Oblivious Monkey
PL202000050

OBLIVIOUS MONKEY GAMING

TITLE SHEET

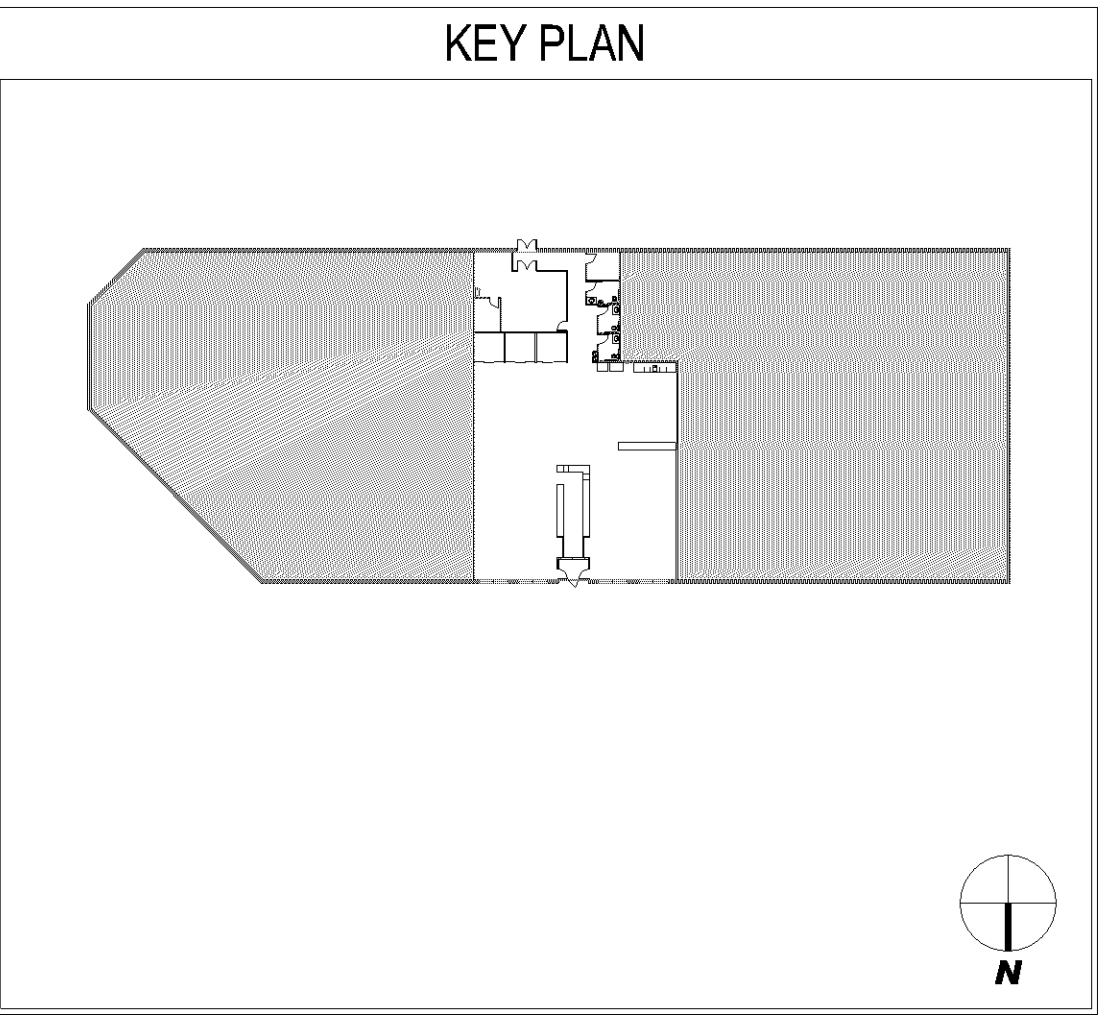
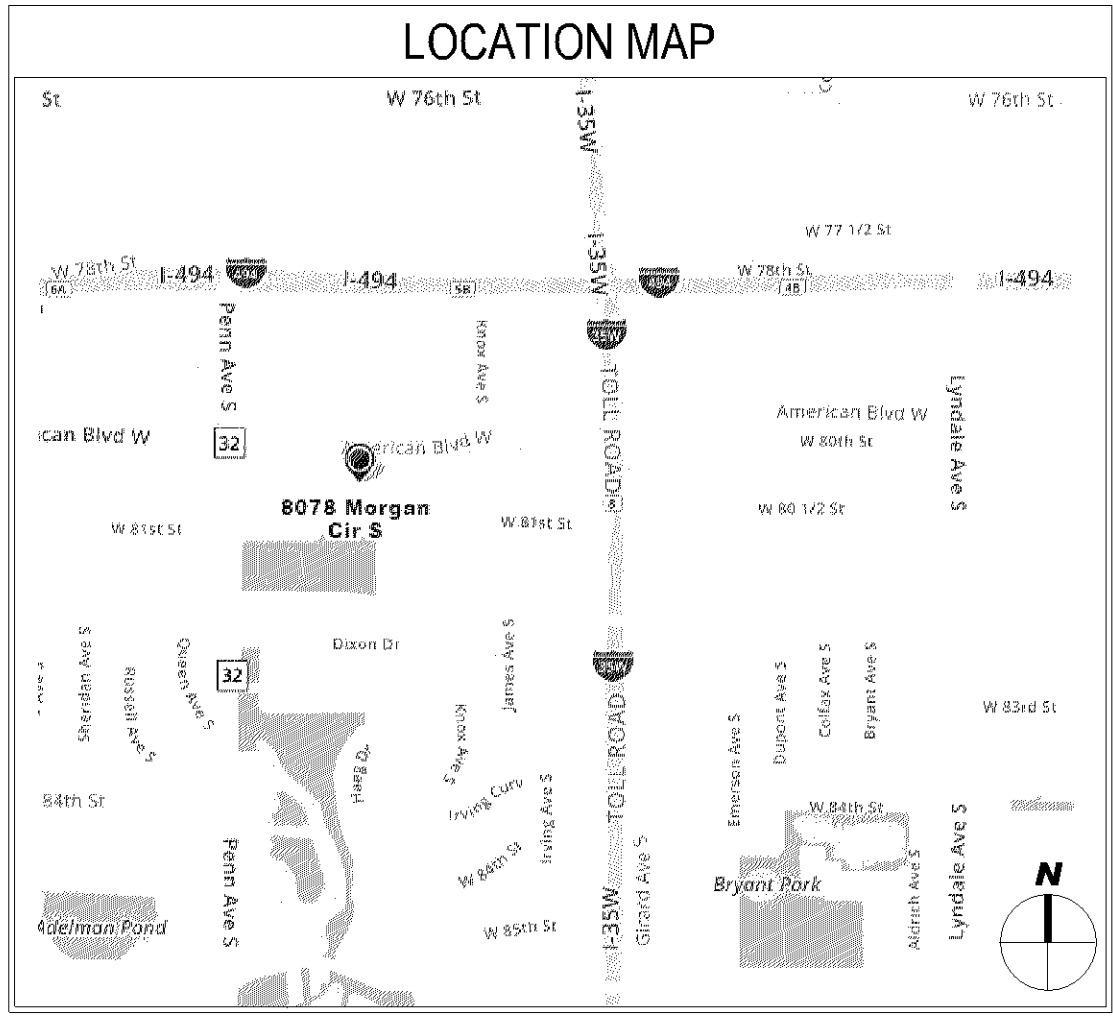
Must meet current MN State
Building Code

Must meet MN Accessibility Code

Provide a code analysis with
the plans.

SAC review by MET council will be
required.

CONSTRUCTION
PLAN - LEVEL 01

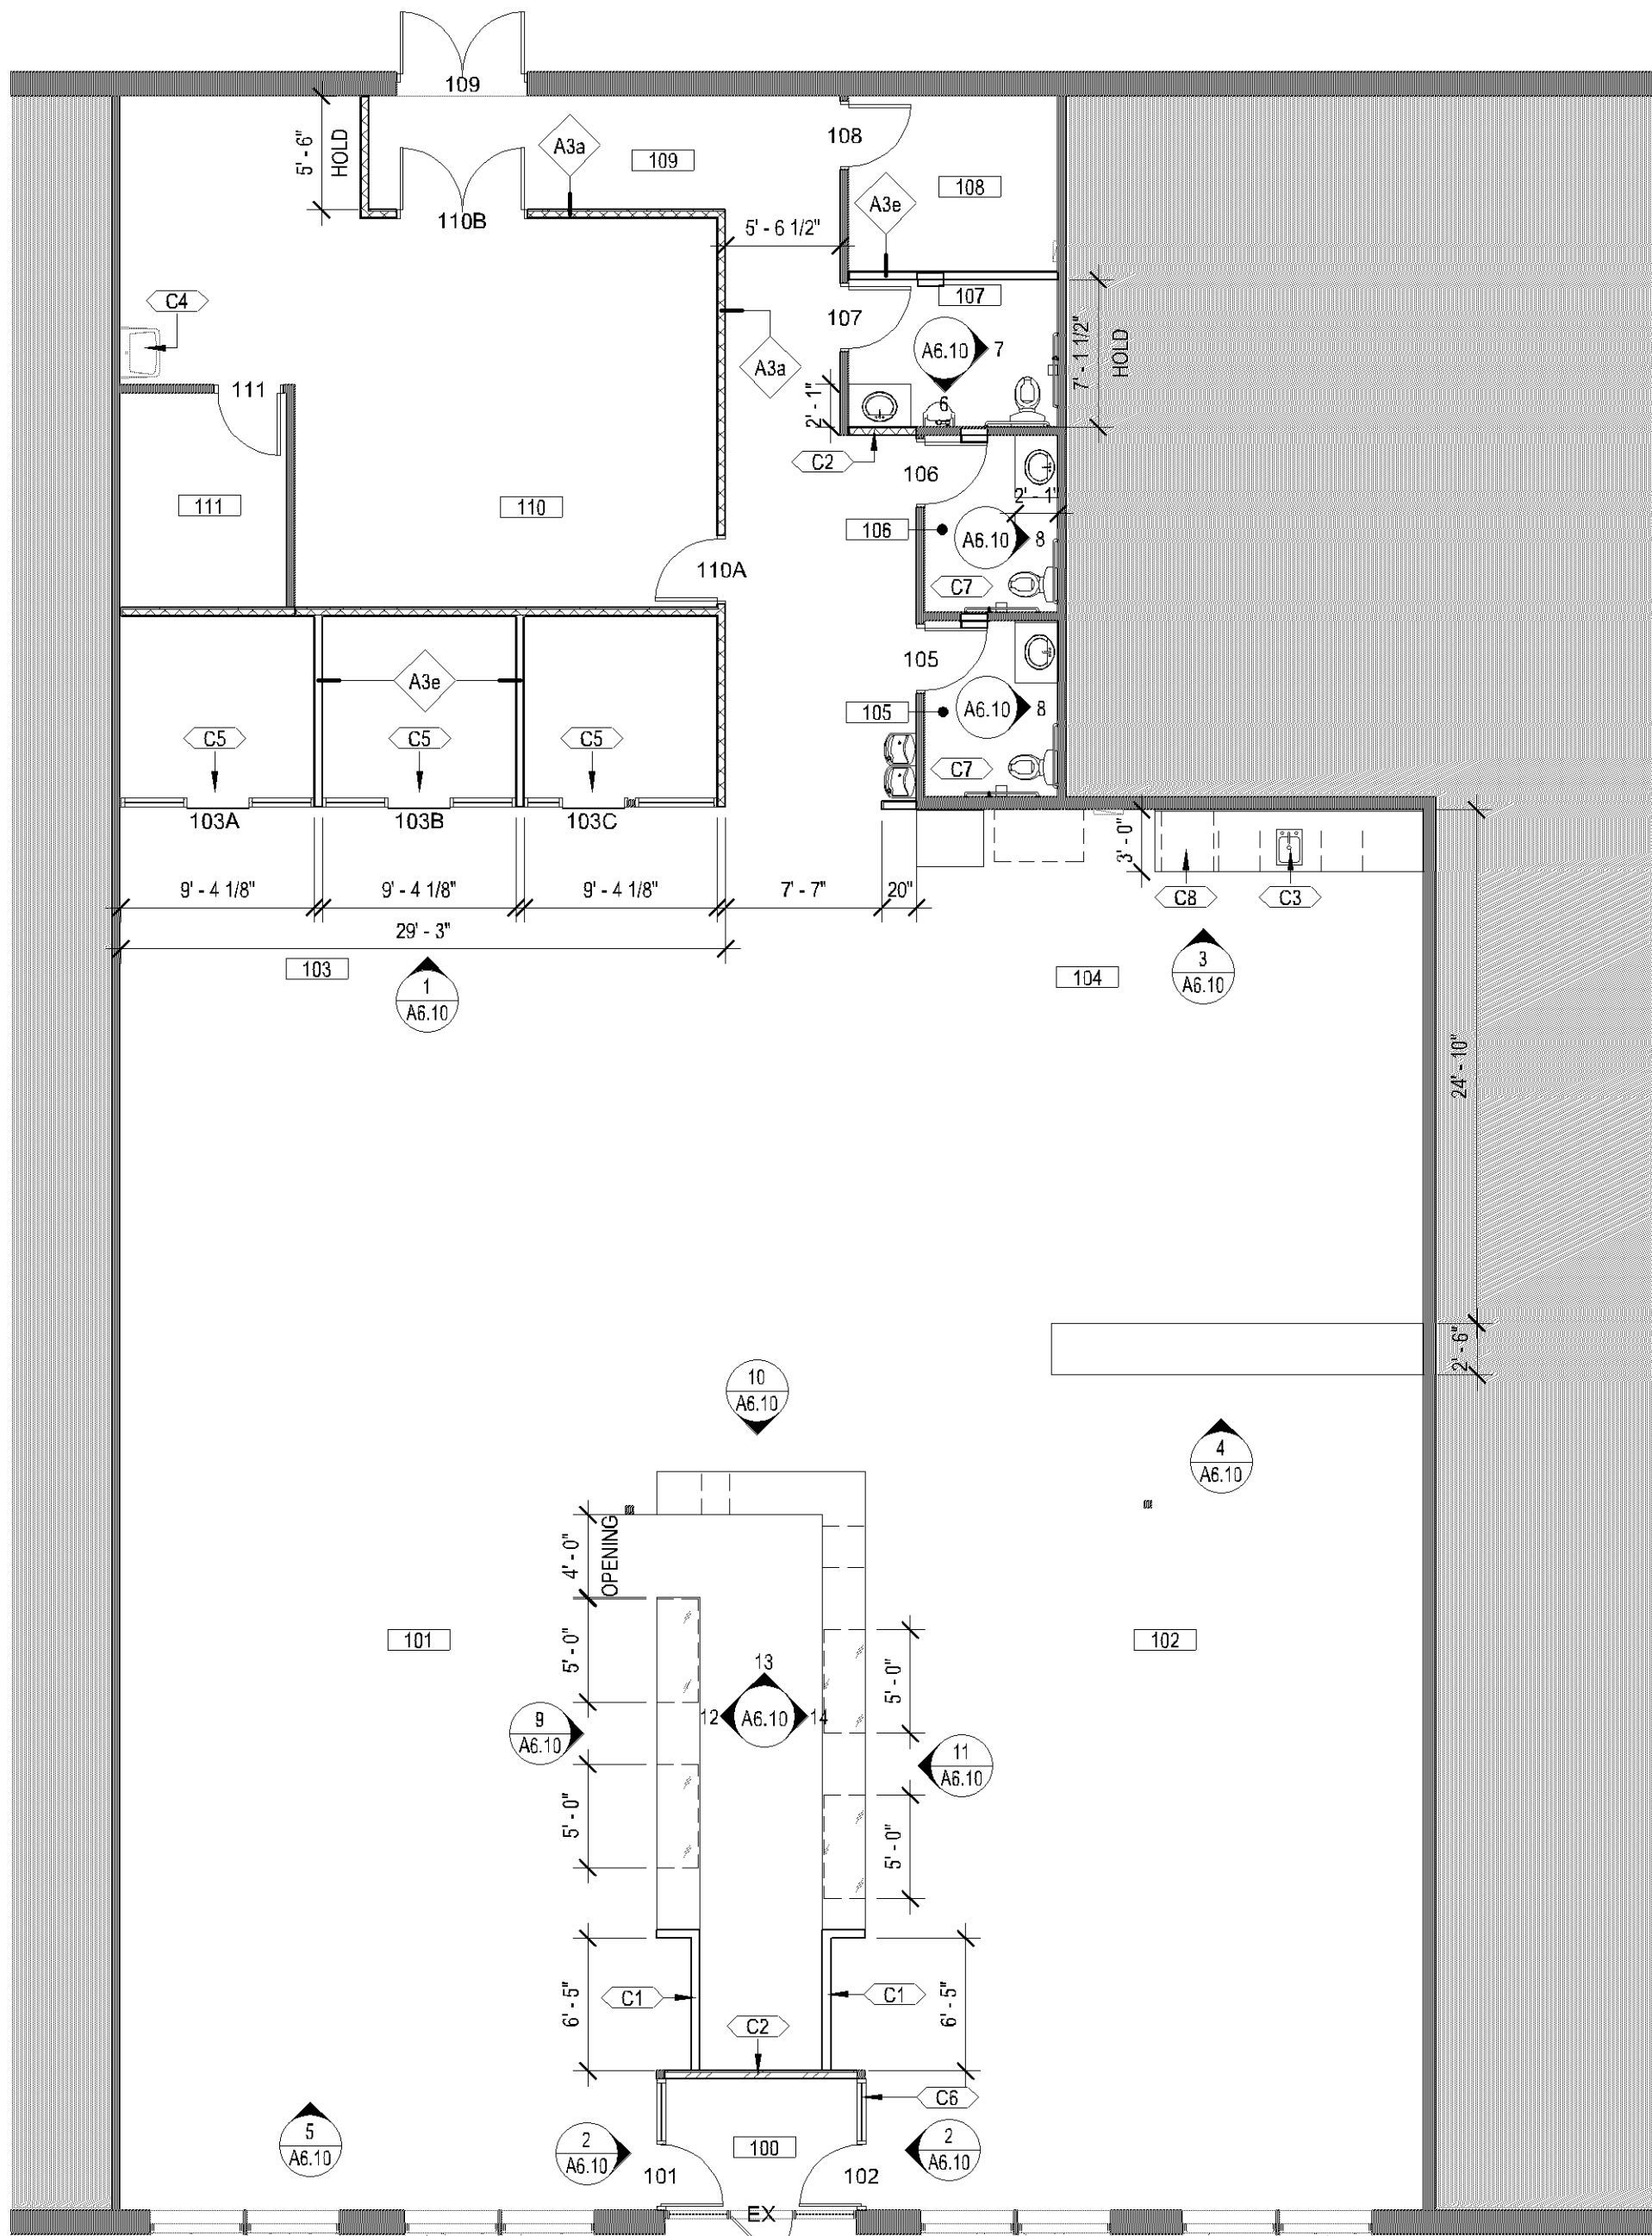
Entire space including individual booths
(with ceilings) shall be sprinklered.

As an assembly occupancy, this space
may be required to have a fire alarm
system.
